Subject: AES Highgrove Project (06-AFC-2)
Data Response, Set 1B

DATA RESPONSE, SET 1B (Responses to Data Requests: 6, 9, 18, 23, 28, 31, 32, 64-67, and 73)

Figure 8.1C-1R

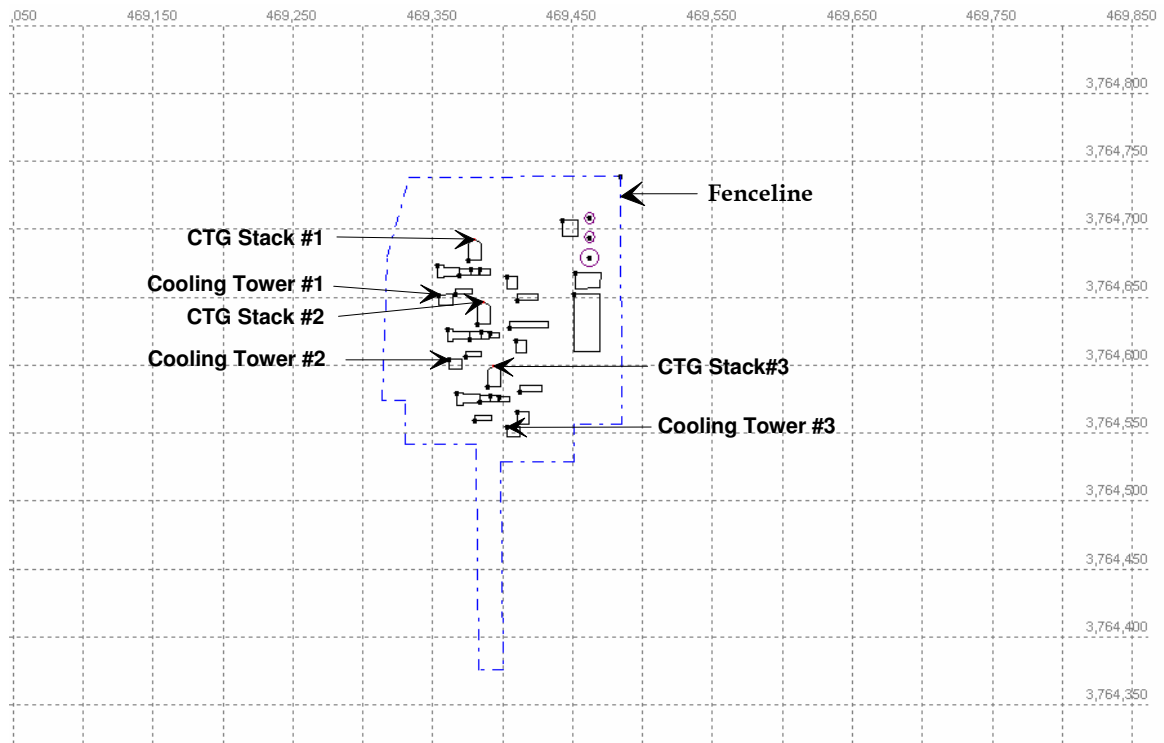
9. If the start-up and shut-down emissions rates and characteristics are revised, please provide a revised modeling analysis showing the facility impacts during start-ups and shut-downs.

Response: AES has modified the site layout based upon new detention basin sizing, increased turbine exhaust stack height, modified cooling tower drift rate and improved access for fire protection. The modifications resulted in a relocation of the detention basin from the south side of the Project Site to the north side, optimizing drainage patterns for the site. Additionally, to make room for a continuous fire access road around the perimeter of the site,

the layout of the major equipment and exhaust stacks have moved slightly. As a result of these changes, AES is providing this revised air quality emissions estimates and model analysis. The revised site layout was presented as Figure 2.2-1R in AES's Data Response, Set 1A (Docket Number 38329).

FIGURE AQ18-1
PERCENT (%) OF THE 24-HOUR PM10 NAAQS
(150 ug/m³)
 AES HIGHGROVE
 GRAND TERRACE, CALIFORNIA

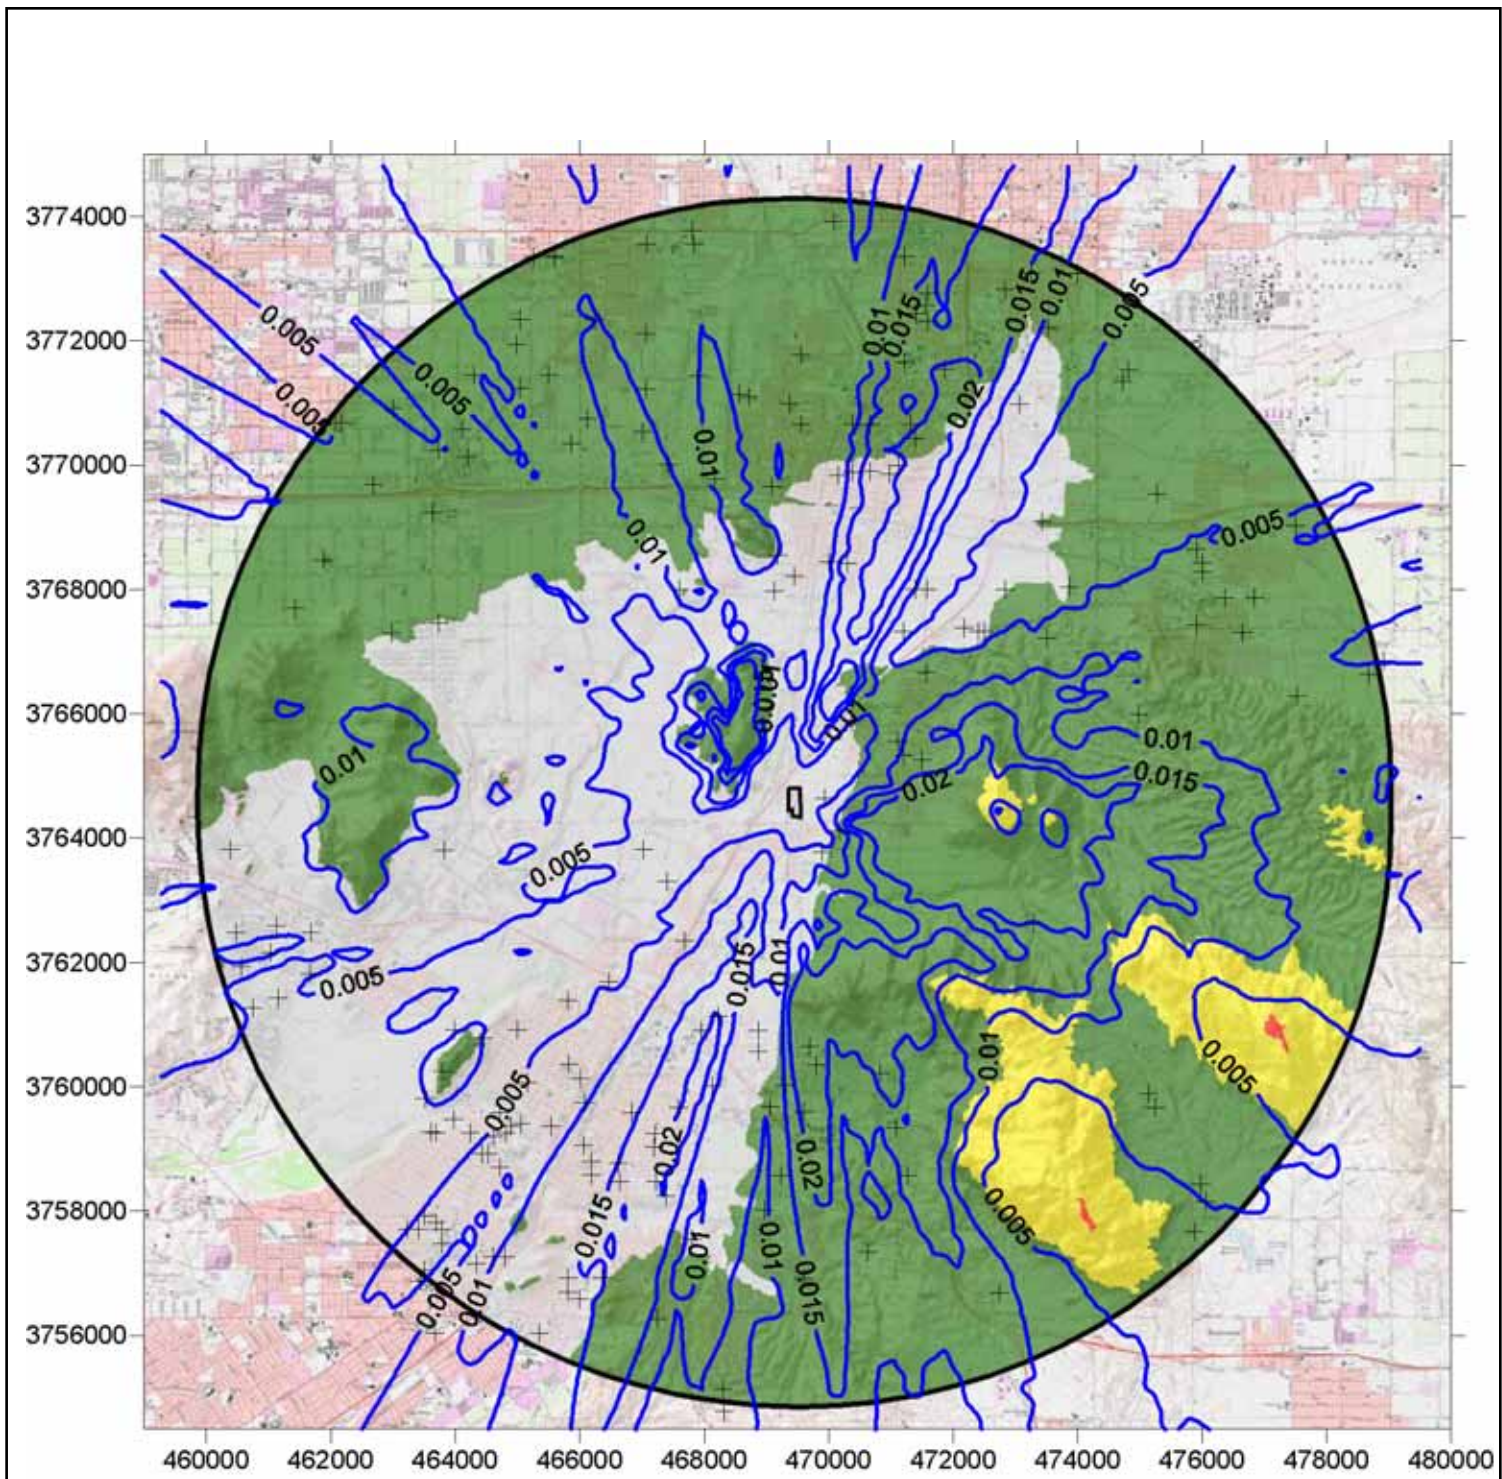
18. Please provide maps showing isopleths of the project's PM₁₀/PM_{2.5} air emission impacts for the maximum 24-hour and annual-average standards and all sensitive receptors listed in the above data request within 10 kilometers of the proposed power plant project site.

Response: Figures AQ18-1 through AQ18-4 present the project's PM₁₀ and PM_{2.5} impacts as a percentage of the federal standards.
